**ITEM 7. DEVELOPMENT APPLICATION: 111-139 DARLINGHURST ROAD AND 224-226 VICTORIA STREET POTTS POINT - FORMER CREST HOTEL****FILE NO: D/2015/331****DEVELOPMENT APPLICATION NO: D/2015/331****SUMMARY**

**Proposal Summary:** Stage 2 Development Application for alterations and additions and a change of use from hotel accommodation (Crest Hotel) to residential development, and retention of retail and bar uses within the podium levels. The proposed development comprises 139 apartments, parking for 56 cars and 134 bicycles, a supermarket of approximately 885m<sup>2</sup> and 2 specialist retail tenancies on Level 1, as well as the retention of existing retail/ commercial premises on the ground floor including a nightclub trading as Goldfish Bowl and a Sports Bar and Gaming Room. Communal open space is proposed on the roof top of the podium, on Level 2. Proposed supermarket trading hours are 24 hours, Monday to Sunday.

**Figure 21:** Podium Level 2 floor plan containing additional apartment storage areas and communal open space and a common room

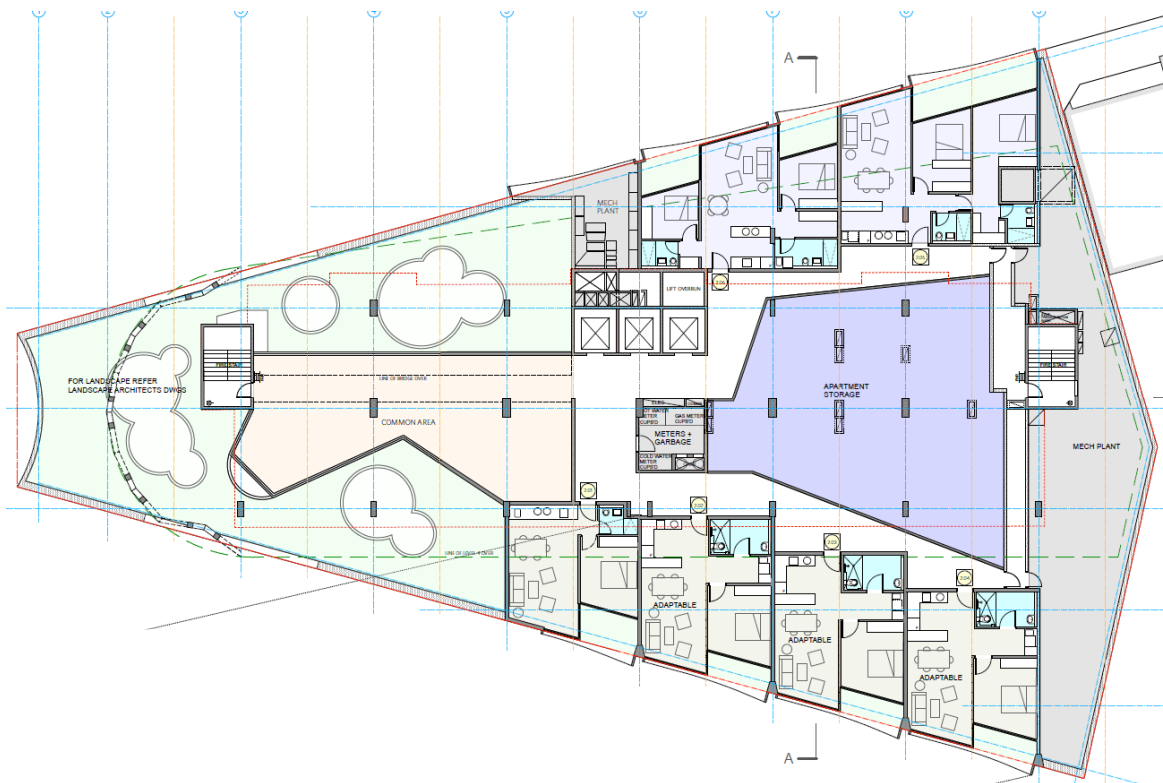
- (c) The apartment storage located on level 2 (Drawing No. 1667.06) is to be relocated to basement level 1 and reconfigured so that it is accommodated within the space occupied by the hydraulic plant which is identified on Drawing No. 1667.03 hydrant tank, sprinkler tank, pcw tank and pumps. The hydraulic plant is to be relocated to level 2 within the area identified as apartment storage on Drawing No. 1667.06. The hydraulic plant is to be appropriately treated in accordance with the relevant Australian Standards to ensure that any noise emissions from the operation of the plant complies with City of Sydney requirements. Amended plans detailing this change are to be submitted to the Director City Planning, Development and Transport for approval prior to the issue of a Construction Certificate.

**Figure 31:** Diagram showing the geometry of the proposal at various levels compared to the approved Stage 1 building envelope

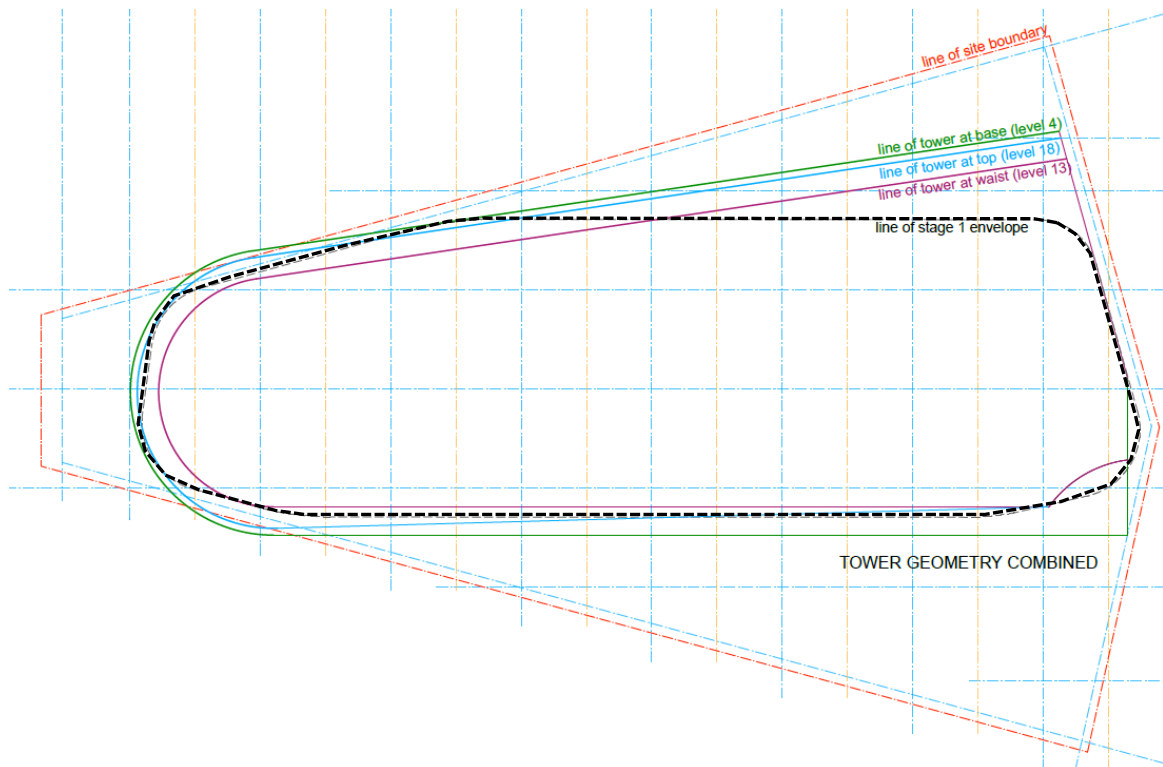
94. With regard to the envelope changes, this is discussed in more detail in the Section 96 application to modify the Stage 1 consent. However, in summary, the envelope changes are shown in figure 31. The north western corner of the tower is proposed to protrude beyond the Stage 1 envelope. This helps give the tower its hourglass and tapered shape. This additional space was a feature of the competition entry and was argued on the basis that there would be no additional view loss or overshadowing as a result of the additional bulk. The selection panel commented that the change to the Stage 1 envelope would require a Section 96 application, which has now been lodged concurrently with the Stage 2 Development Application.

**Figure 37:** Example of an undersized 1 bedroom apartment adjoining an undersized studio that can be reconfigured to provide an appropriately sized 2 bedroom apartment

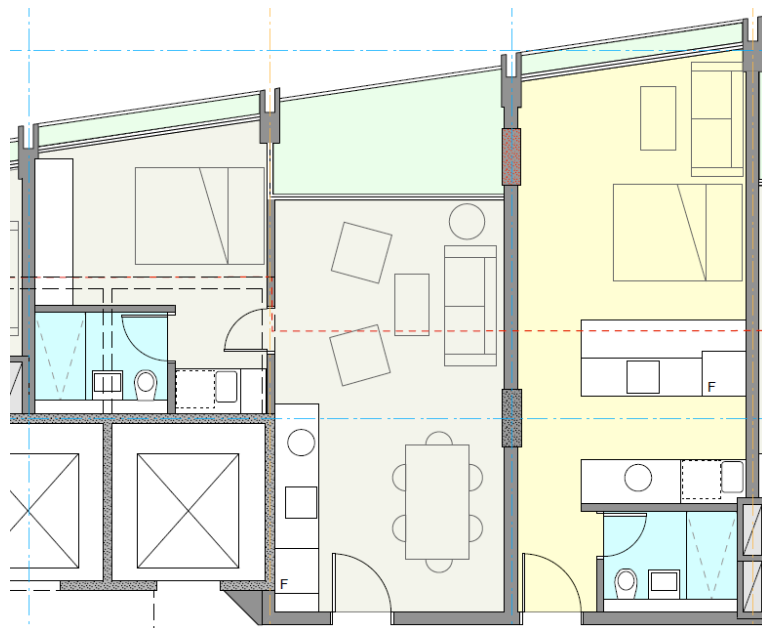
108. On Levels 6, 8 and 10, studios of less than 35m<sup>2</sup> are located next to 1 bedroom apartments which are between 5m<sup>2</sup> and 10m<sup>2</sup> below the minimum size requirement of 50m<sup>2</sup> under the RFDC and the ADG (refer to Figure 37). These adjoining studios and 1 bedroom apartments are recommended to be reconfigured and amalgamated to create appropriately sized 2 bedroom apartments. This will result in 6 apartments being reduced to 3 apartments.

**Figure 38:** Example of an undersized 2 bedroom apartment at the southern end of the tower that can be reconfigured to provide an appropriately sized 1 bedroom apartment

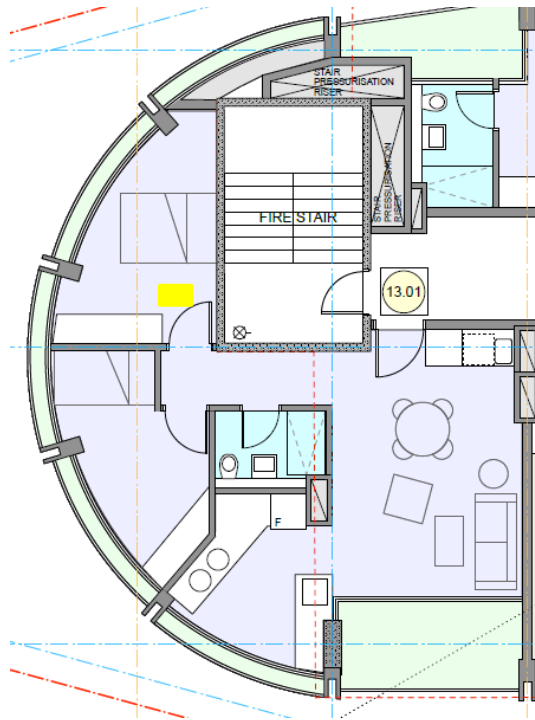
110. On Levels 10, 12, 13, 14, 15, 16 there are a total of 6 two bedroom apartments located at the southern end of the tower that are between 5m<sup>2</sup> and 18m<sup>2</sup> below the minimum size requirement of 70m<sup>2</sup> under the RFDC and the ADG (refer to Figure 38). These apartments recommended to be reconfigured to reduce the number of bedrooms to 1, which will make them compliant 1 bedroom apartments. This will not reduce the number of apartments, however, it will redesign the existing affected apartments.

**Figure 39:** Example of adjoining undersized 1 bedroom apartments that can be reconfigured to provide an appropriately sized 2 bedroom apartment

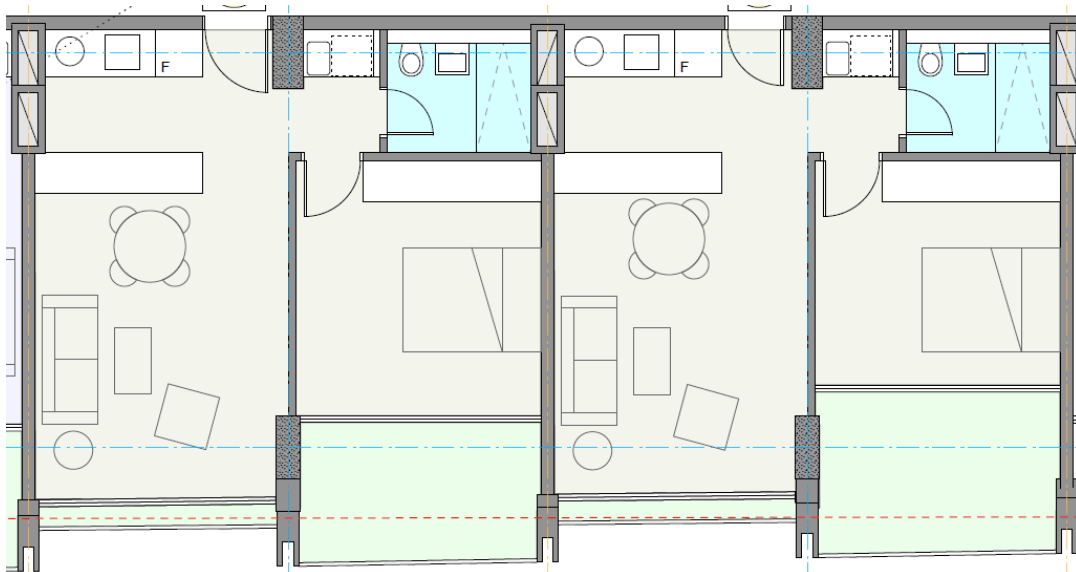
111. On Levels 12, 13, 14, 15, and 16 the proposal provides 10 adjoining one bedroom apartments with an eastern orientation that are between 5m<sup>2</sup> and 8m<sup>2</sup> below the minimum size requirement of 50m<sup>2</sup> under the RFDC and ADG (refer to Figure 39). These adjoining studios and 1 bedroom apartments are recommended to be reconfigured to create appropriately sized 2 bedroom apartments. This will reduce the number of apartments by 5.
